reACT

U.S. DEPARTMENT OF ENERGY - SOLAR DECATHLON 2017 SUBMISSION

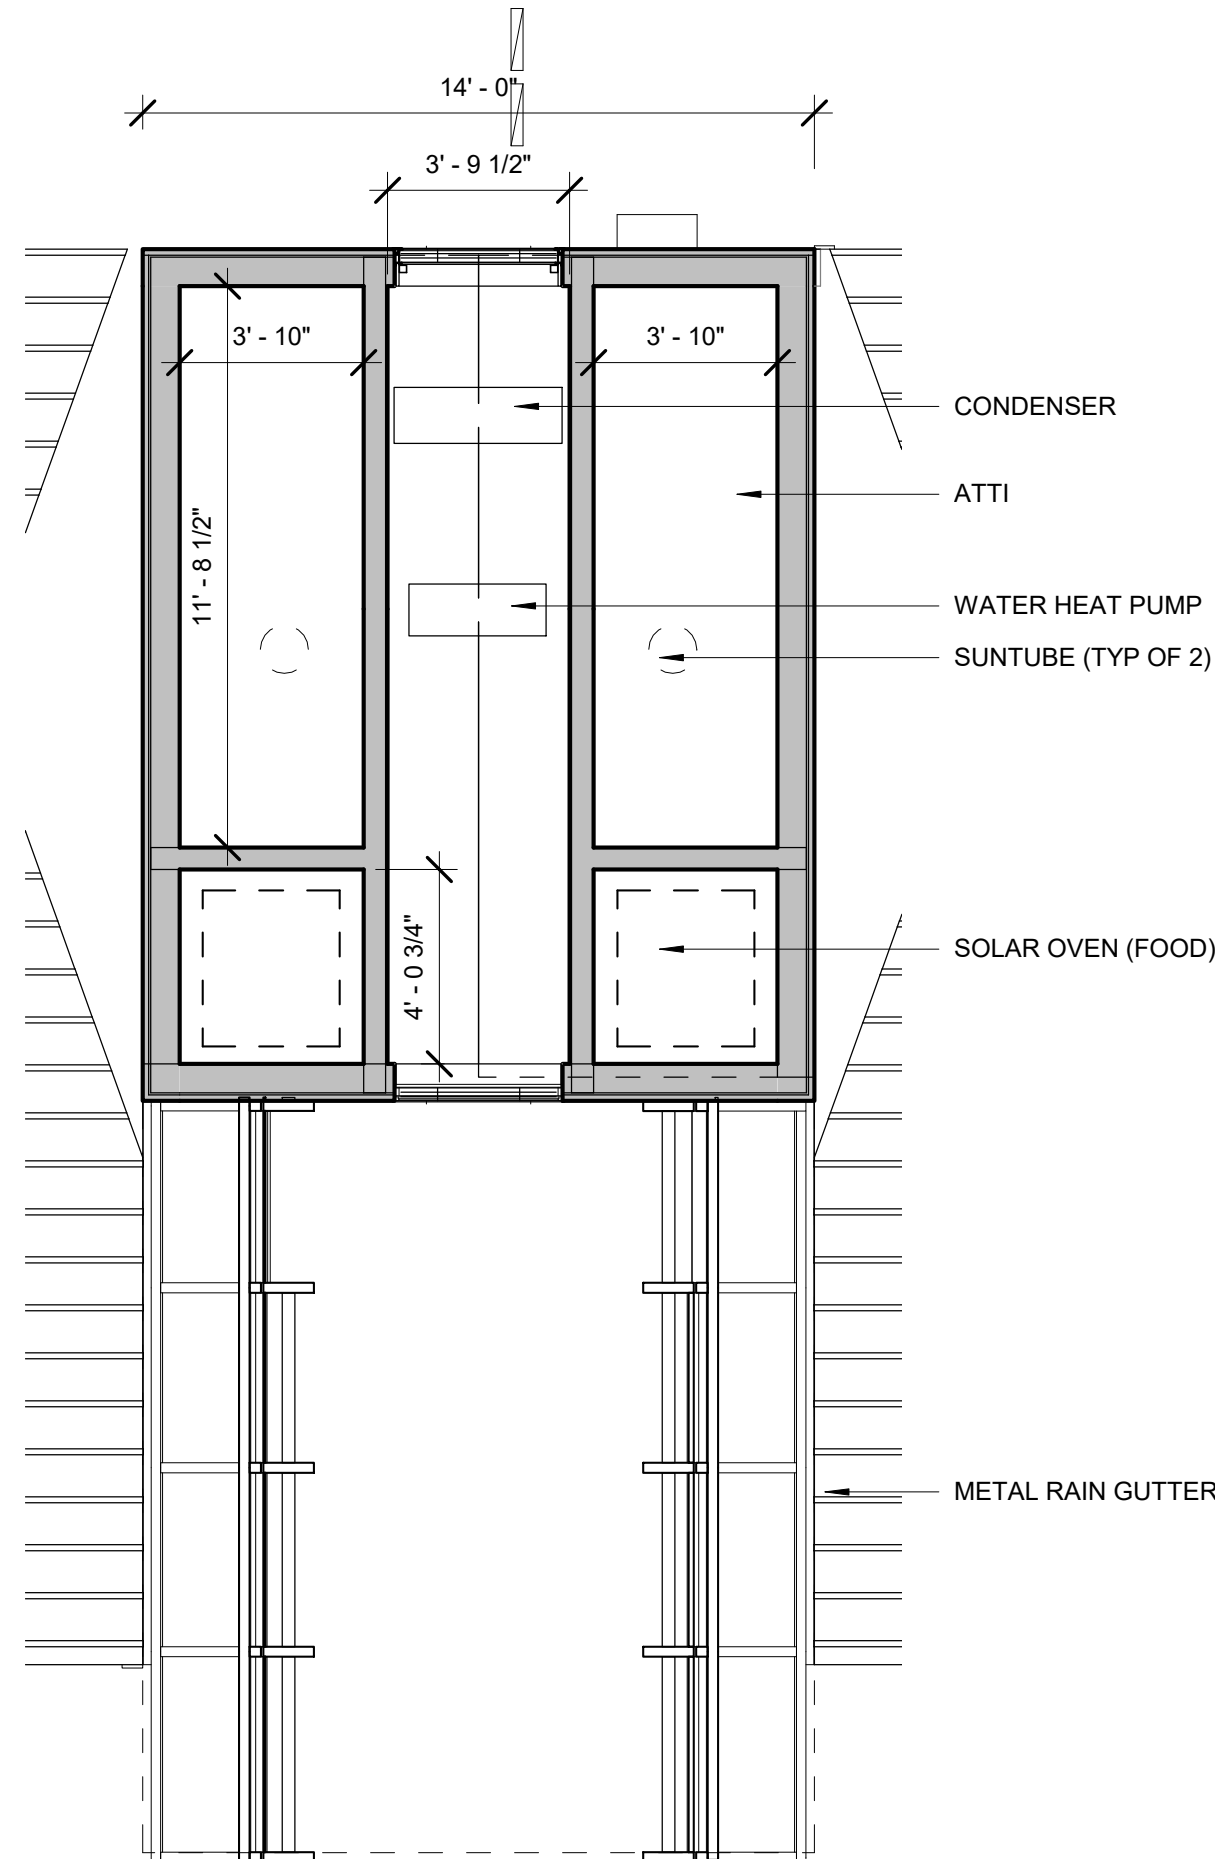
- A. FOR FINISH LEGEND REFER TO A-103
- B. FOR ADDITIONAL FINISH INFORMATION REFER TO A-400 SERIES - ENLARGED PLANS AND ELEVATIONS
- C. FOR ADDITIONAL FINISH INFORMATION REFER TO A-104 FOR FINISH FLOOR PLAN
- D. FOR FINISH OF DOOR & FRAMES & THRESHOLD DETAILS REFER TO A-600 SERIES - DOOR AND WINDOW SCHEDULES
- E. WHERE MULTIPLE FINISHES ARE SHOWN AT WALLS REFER TO INTERIOR ELEVATIONS OR ENLARGED DETAILS FOR CLARIFICATION
- F. INTERIOR FINISHES AND MATERIALS REFER TO ARCHITECTURAL SPECIFICATIONS
